# City of Sandy

### Planning Commission Meeting

**Meeting Date:** Monday, April 22, 2019

**C4.0**

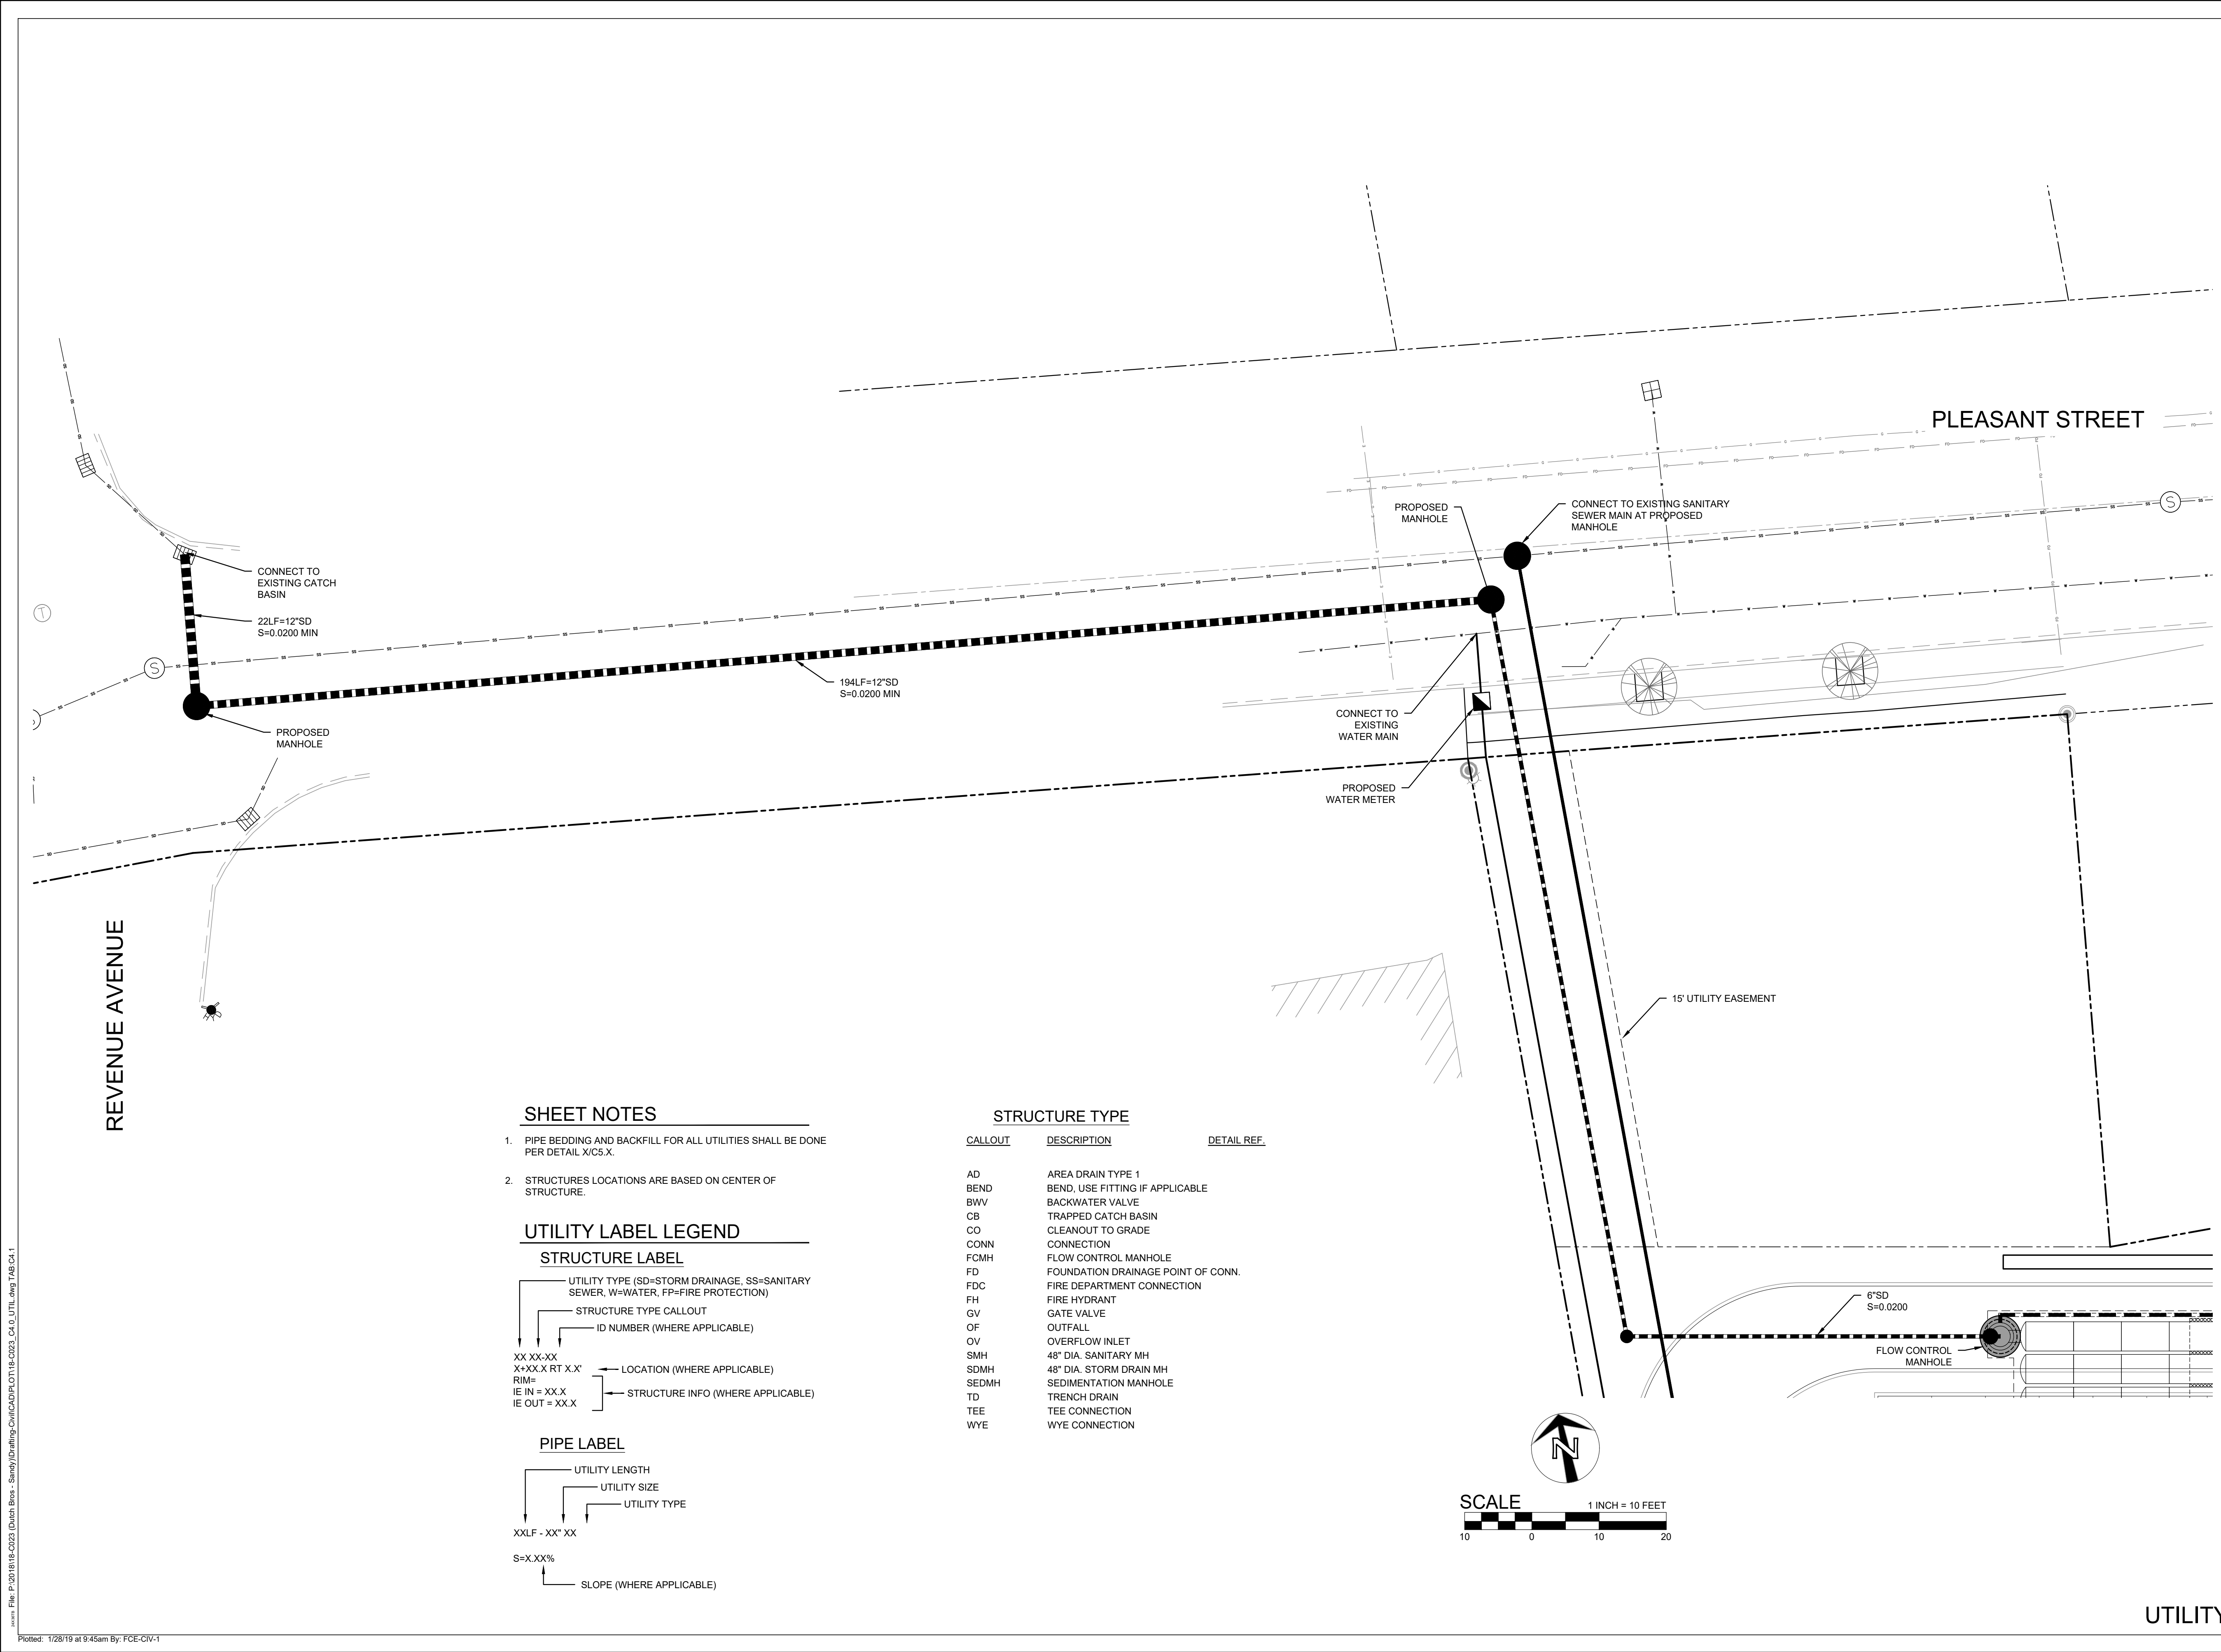
**RESPONSE:** *The applicant's utility plan (Exhibit I, Sheets C4.0 and C4.1) depicts the location and type of proposed public utilities including water and sanitary sewer. All public utility installations shall conform to the City's facilities master plans. All public sanitary sewer and waterlines shall be a minimum of 8 inches in diameter and all stormwater drains shall be a minimum of 12 inches in diameter. No building permits will be issued until all public utilities, including sanitary sewer are available to serve the development. The applicant shall pay plan review, inspection, and permit fees as determined by the Public Works Director.*

**RESPONSE:** *The applicant’s utility plan (Exhibit I, Sheets C4.0 and C4.1) depicts the location and type of proposed public utilities including water and sanitary sewer. All public utility installations shall conform to the City’s facilities master plans. All public sanitary sewer and waterlines shall be a minimum of 8 inches in diameter and all stormwater drains shall be a minimum of 12 inches in diameter. No building permits will be issued until all public utilities, including sanitary sewer*

**COMMENT: Utility Plans are included with Site / Civil Plans (C4.0, C4.1) with this submittal and are intended to meet the listed criteria.**

**COMMENT:** Parking areas and on-site drainage collection is accomplished via surface collection and below grade conveyance and is detailed on Civil Plans / Utility Plans (Sheet C4.0, C4.1). The site has been divided into small drainage basins to minimize the quantity of surface runoff. Stormwater is managed on site to the maximum extent possible. This project meets this requirement.

**L10**

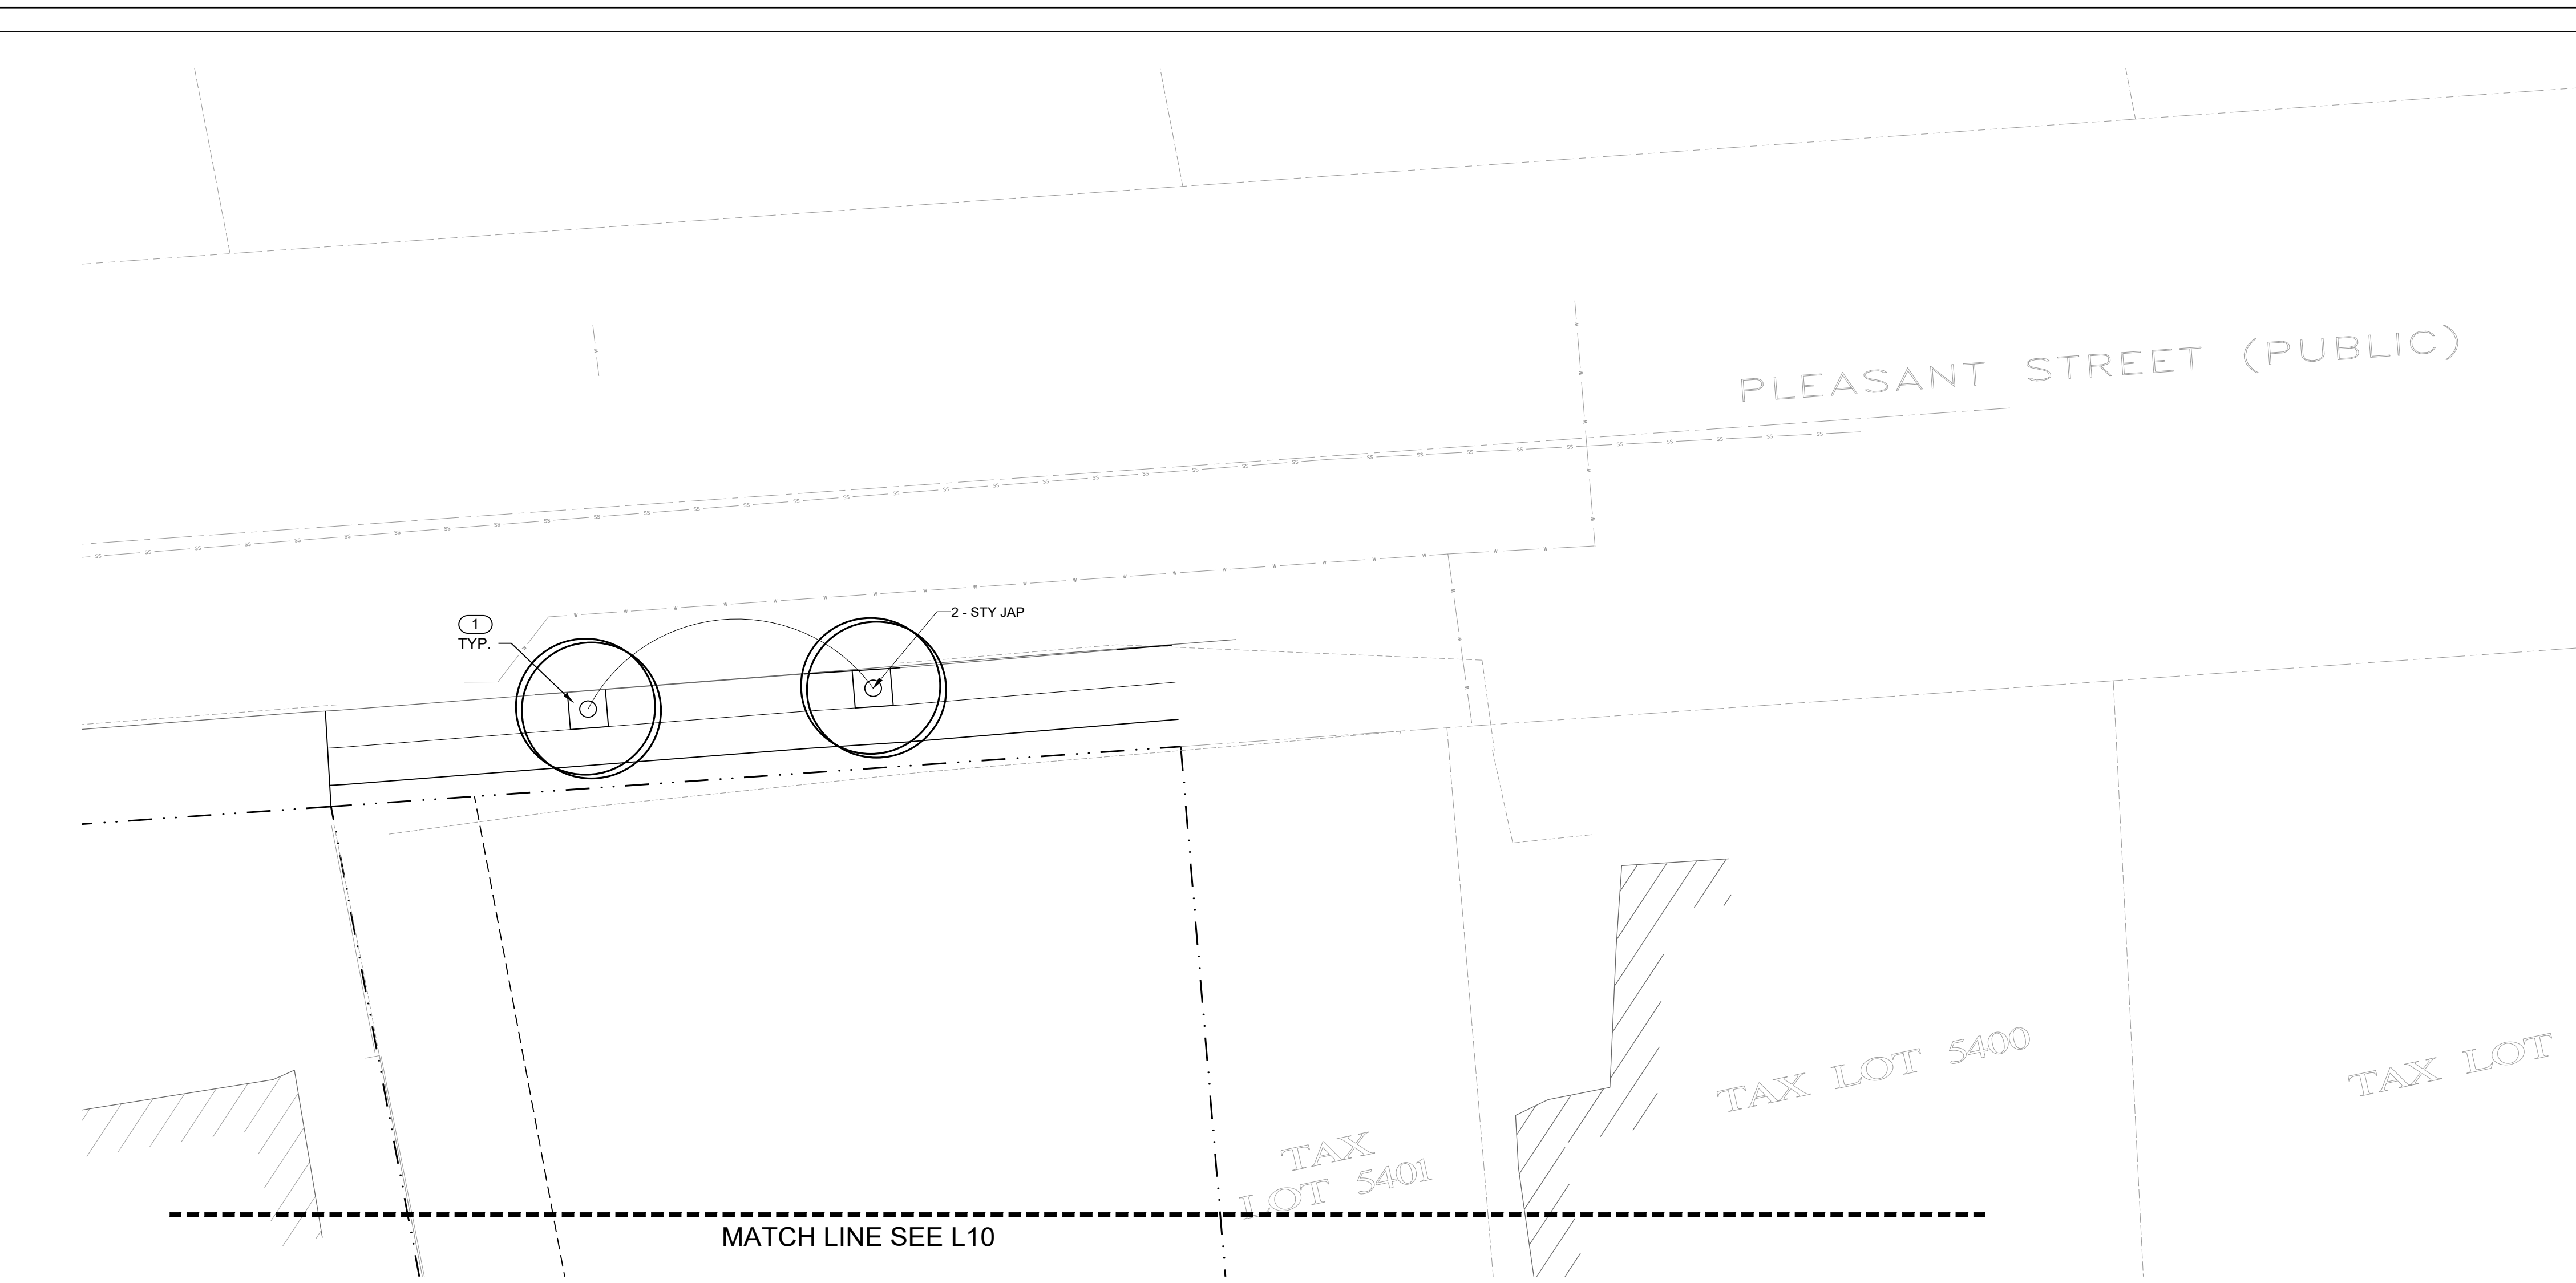
**RESPONSE:** *The submitted landscaping plans (Exhibit I, Sheets L10 and L11) indicates the “all planting areas” shall be equipped with an automatic drip irrigation system. All trees on the subject property shall be equipped with drip loops on separate zone. **The applicant shall demonstrate compliance with this proposal at time of building permit.***

**RESPONSE:** *The Landscape Plan (Exhibit I, Sheets L10 and L11) identifies the following street trees at 2.0- inch caliper:*

**RESPONSE:** The subject property is zoned Central Business District, C-1. Section 17.92.20 requires that a minimum of 10 percent of the site be landscaped in the C-1 zone district. The submitted Landscape Plan (Exhibit I, Sheets L10) identifies PPI at a total of 21,787 square feet with a total landscaped area of 4,072 square feet which equates to a total of 18.7 percent of the site containing landscaping.

**RESPONSE:** The submitted landscaping plans (Exhibit I, Sheets L10 and L11) indicates the “all planting areas” shall be equipped with an automatic drip irrigation system. All trees on the subject property shall be equipped with drip loops on separate zone. **The applicant shall demonstrate compliance with this proposal at time of building permit.**

COMMENT: The project shall be equipped with a permanent, below-grade, automatic drip irrigation system per planting note 4 on sheet L10.
